# TAB Punchlist

**L05629\_Langhorne (PA) FSU**

1440 Lincoln Highway, Langhorne, Pennsylvania

## #29 [EXHA 999] [NEW] (MISC) Grease cleanout

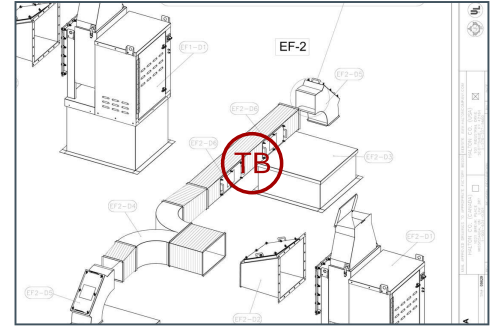
EF-2 needs another Greas cleanout installed on the Runout for HD-2. Specd is two cleanout in the run only one is cut-in and installed.

## #28 [HOOD 508] [NEW] Sidejet arm angle bracket.

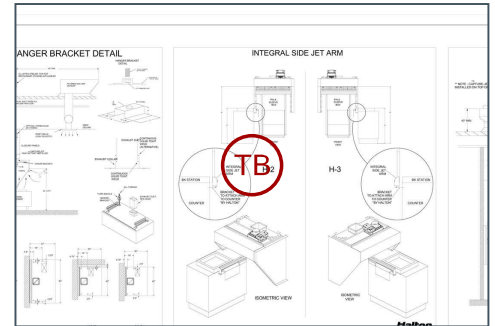
(HD-2)The Halton supplied angle bracket that connects the integral sidejet arm to the counter is missing or not installed correctly. Secure bracket to arm and bracket to counter underneath removeable fry dump via stainless steel rivets.

## #26 [UNIT 504] [NEW] Equipment Fresh Air Tempering.

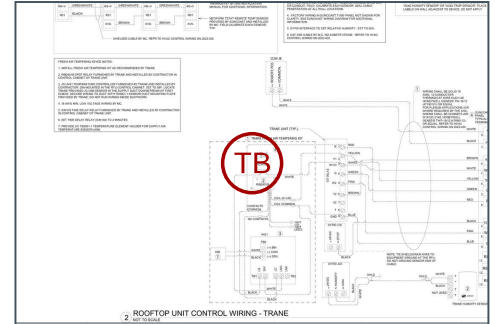
104 Timers are not functioning correctly. It was observed Heating turns on immediately after cooling stops and runs for approximately 1 min before turning off

## #24 [UNIT 517] [NEW] Condensate piping construction.

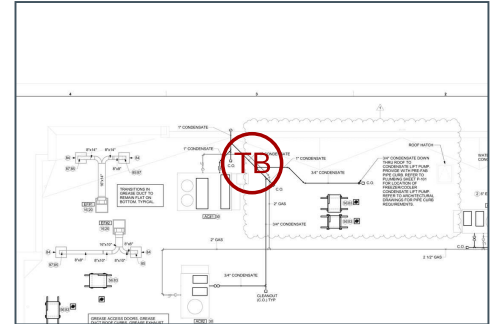
Equipment condensate piping Roof routing does not match prints.

## #23 [UNIT 523] [NEW] Trane powered exhaust.

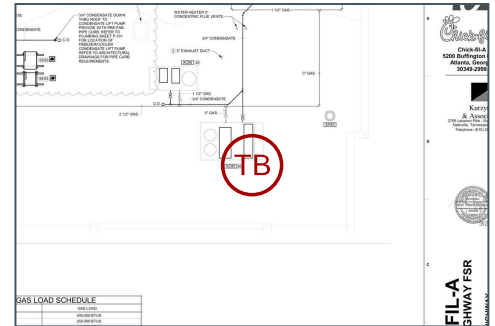
AC-3 Powered Exhaust fan wheel does not spin freely and rubs.

Item Reopened, Powered exhaust fan is rubbing again\

MC has adjusted the fan wheel and now spins freely.

## #19 [REFG 516] [NEW] Condenser electrical disconnects.

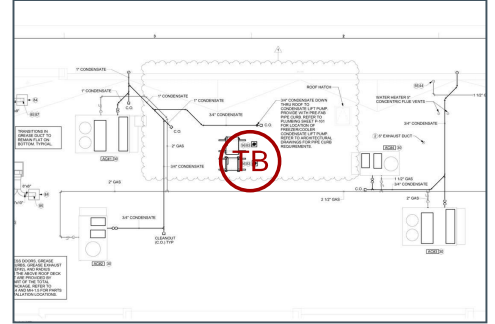
**Description**  
Electrical disconnects are properly labeled.

## #18 [REFG 999] [NEW] (MISC) WIF Thermometer

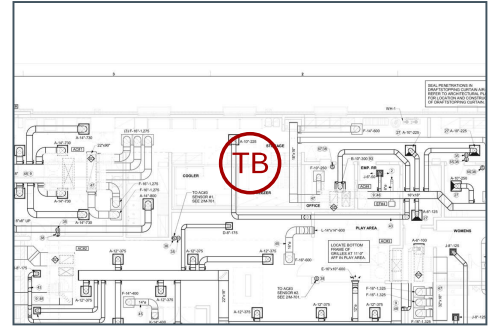
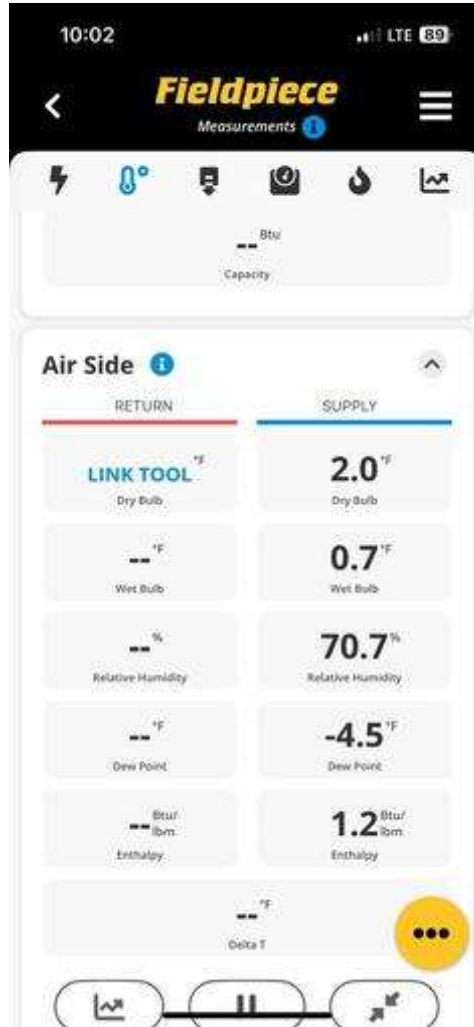
WIF Thermometer is not reading true to the Freezer Temp, Inside was 2F and thermometer is reading -15F
